TECO's Response to OPC's Third Set of
Interrogatories Nos. 51-149

**TAMPA ELECTRIC COMPANY
DOCKET NO. 20220048-EI
OPC'S THIRD SET OF
INTERROGATORIES
INTERROGATORY NO. 51
BATES PAGE: 1
FILED: MAY 25, 2022**

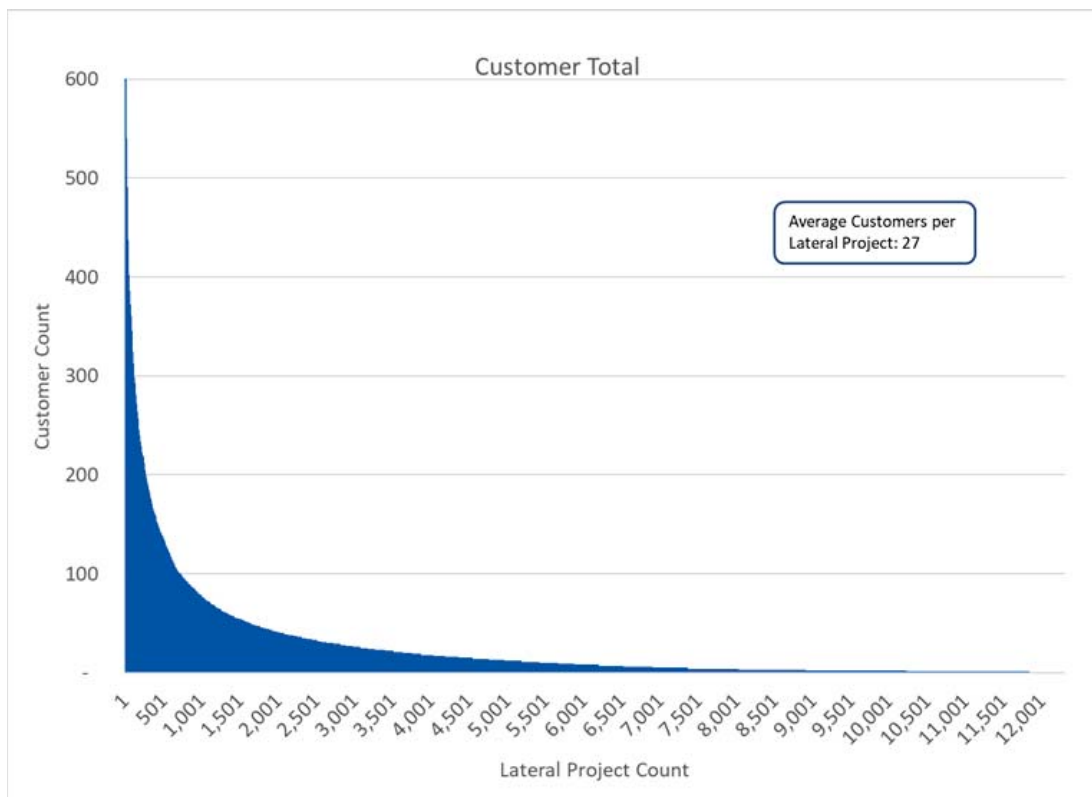
70. Referring to Exhibit DAP-1, Page 31 and 32 of 78, regarding prioritizing undergrounding of laterals, is it less costly to underground all the laterals on a feeder rather than using a priority system where the laterals to be undergrounded are spread over a wider area? If so, why? If not, please explain.

A. Tampa Electric has not run that specific analysis so is unable to answer this question in its current form. The company has identified that it is more cost effective to do larger projects when compared to the smaller projects. It appears the ideal project size is around 1.5 miles, or greater, from the small sample set the company has performed to date. This data is supported by the cost per mile seen from the recent projects the company has completed. The company described the change in project definition and project scope size in the SPP and testimony and in the company's response to Interrogatory No. 69, above.

The company also incorporated geographic diversity into its prioritization for lateral undergrounding. At the core of the company's philosophy on the SPP is that it is a customer program, and all customers are sharing in the incremental cost. As such, all customers should benefit from the SPP and the programs. The company's projects, specifically in the Distribution Lateral Undergrounding Program, were intentionally grouped into four geographic buckets and then prioritized to ensure the projects and benefits were spread across the company's service territory.

In addition, in preparing the SPP, Tampa Electric and 1898 & Co. carefully considered the tradeoffs between approaches. It is important to note that a significant cost of lateral undergrounding is customer engagement. These costs will be significantly higher in an approach where lateral undergrounding is spread out across the entire system. To balance the cost efficiencies with benefit efficiencies, Tampa Electric took a hybrid approach. The modeling effort first identified all the laterals to underground for the 10 years. This factors in the benefit efficiencies. Then the model scheduled each of the laterals to execute all the laterals on a circuit in the same year. This approach allows for cost efficiencies and spread the work around the system over the 10 year horizon.

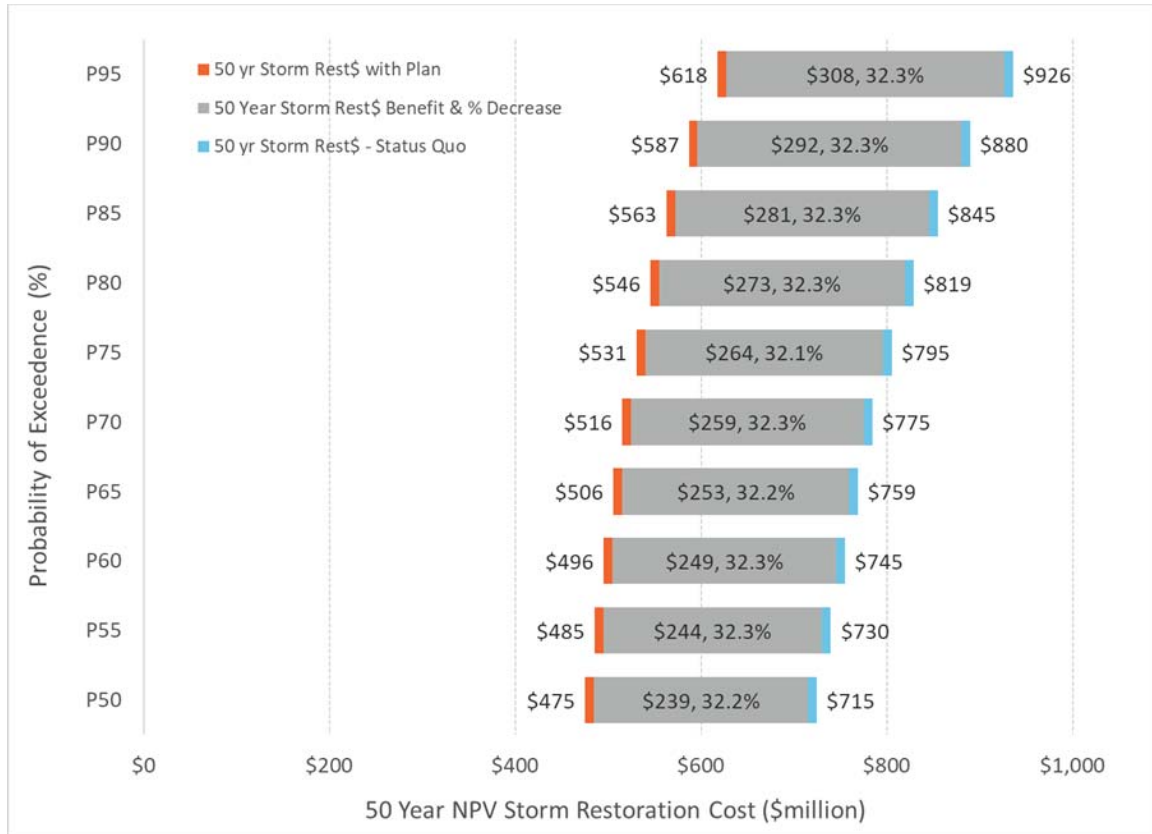
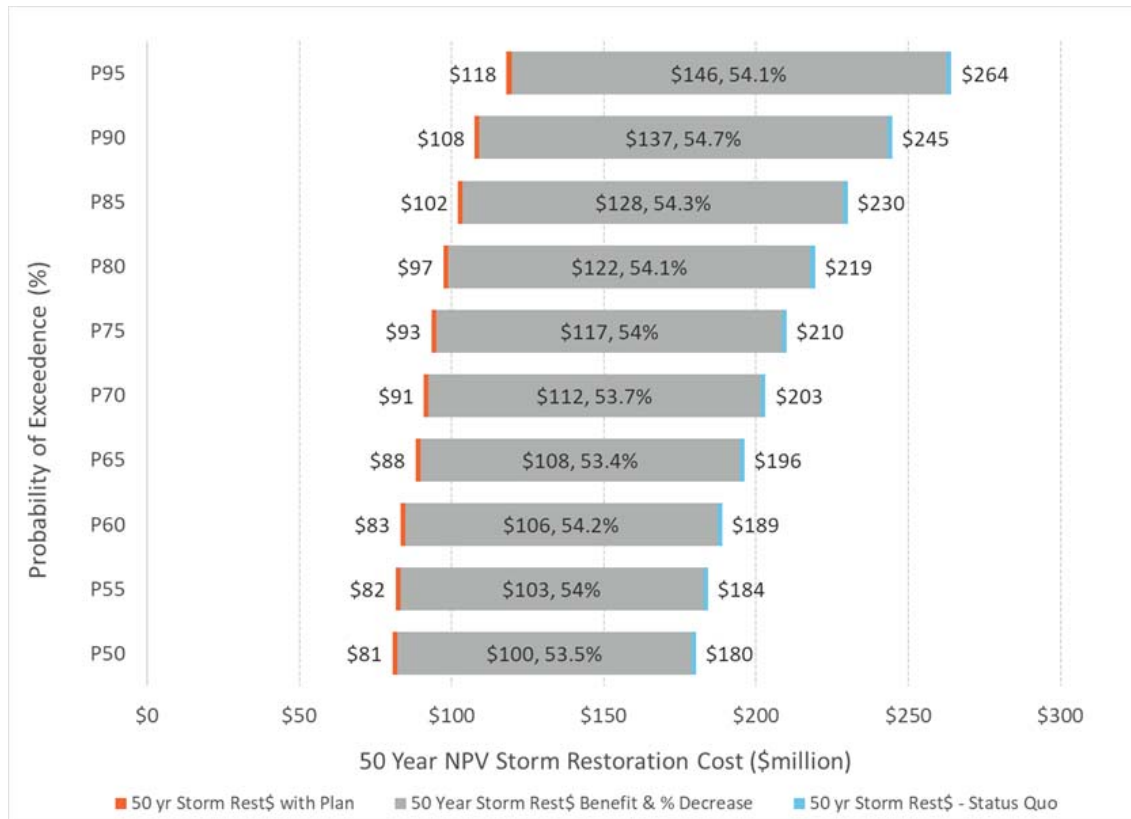
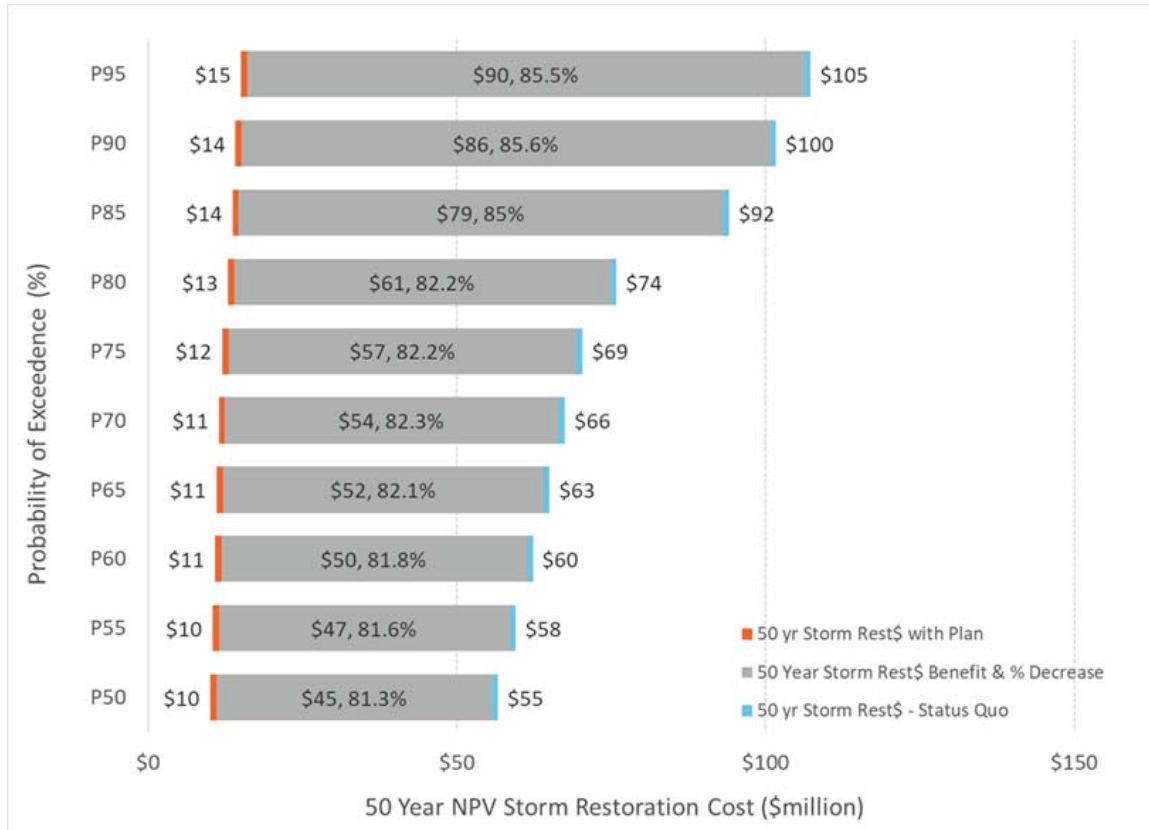
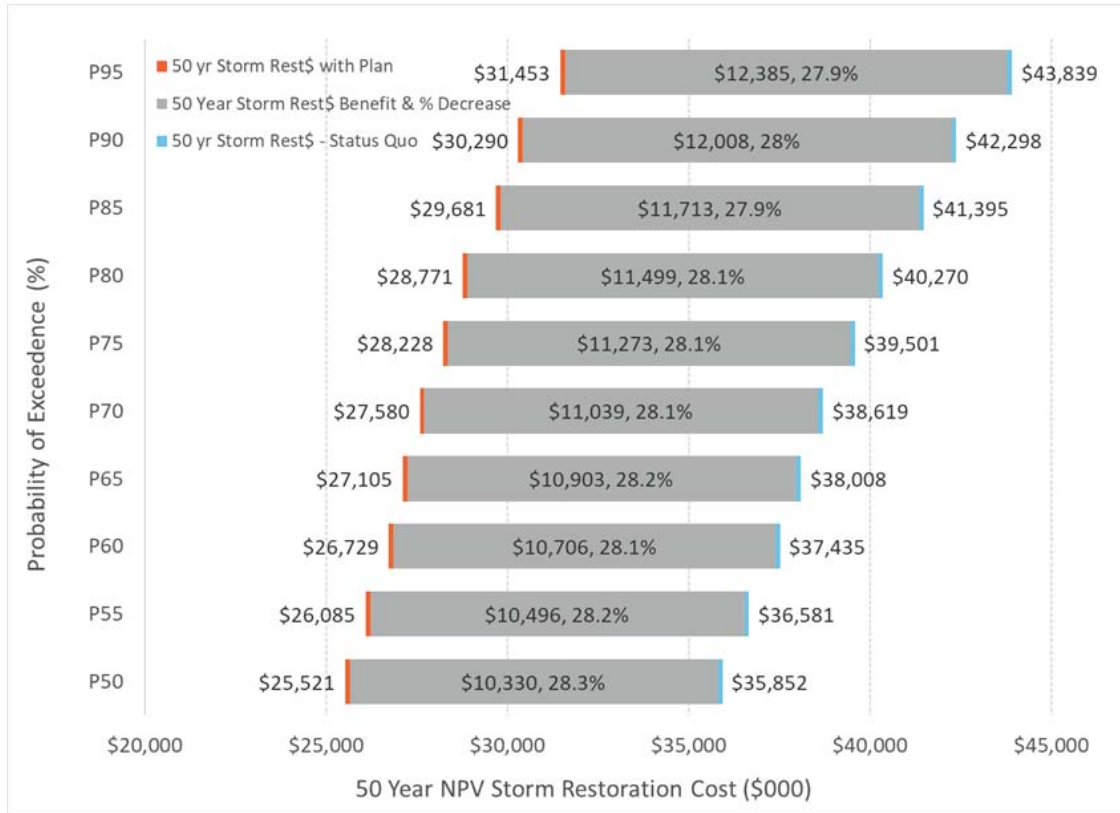
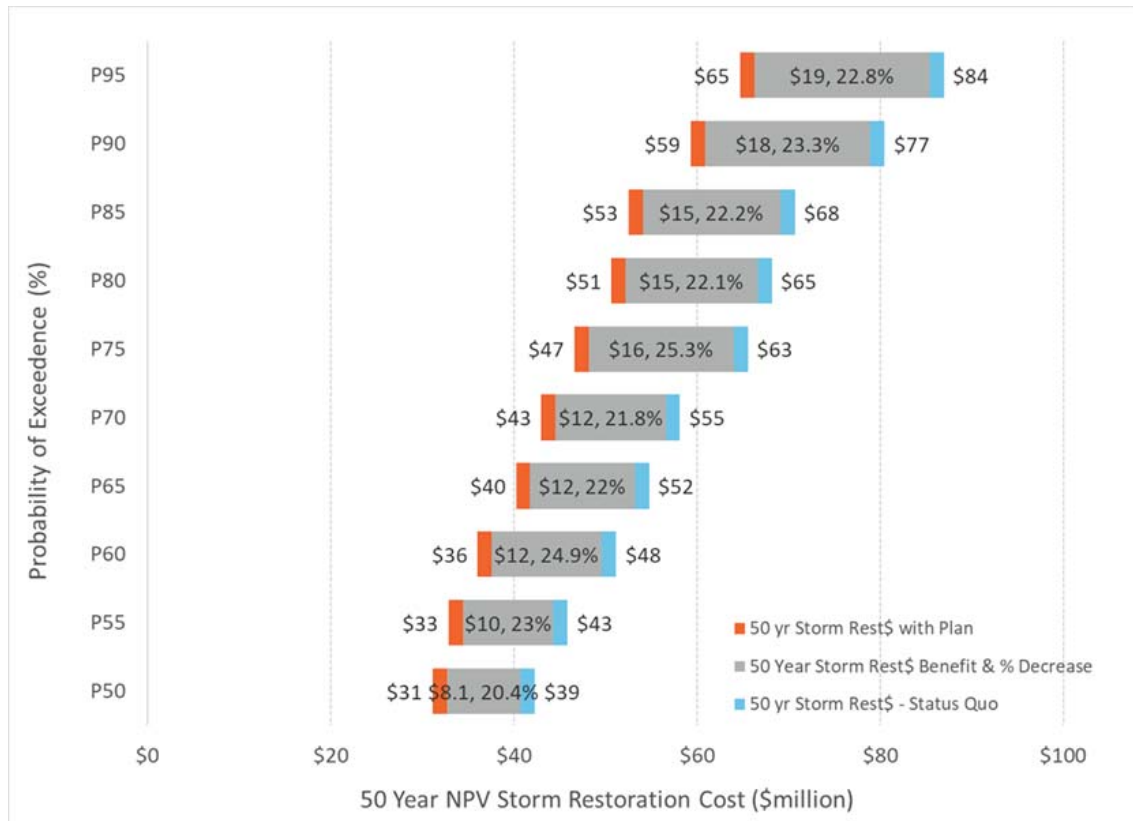
134. Referring to Exhibit DAP-1 page 71 of 78:

- a. Provide actual costs in reduction in restoration costs for storm protection program.
- b. Describe the term of reduction costs (annual, ten years, life of the assets, etc)
- c. Provided projected annual cost reduction for the next ten years.
- d. Provide actual customer minutes of interruption before improvements and after improvements.
- e. Describe the term of reduction costs (annual, ten years, life of the assets, etc)
- f. Provided projected annual cost reduction for the next ten years.

A. a. Assuming 'actual cost' is the modeled status quo for the percentage reduction calculation. For each of the programs, the following figures shows:

- 1. Range of the Status Quo 50-year storm restoration costs (blue bars)
- 2. Range in the 50-year storm restoration costs after the 10 years of investment in hardening projects (orange bars)
- 3. Difference and percent difference between each of the range values (grey area)

The percentage in the grey areas map to the values in the table on page 71 of 78 references in the question. Adding all these figures together produces the results for the entire plan.
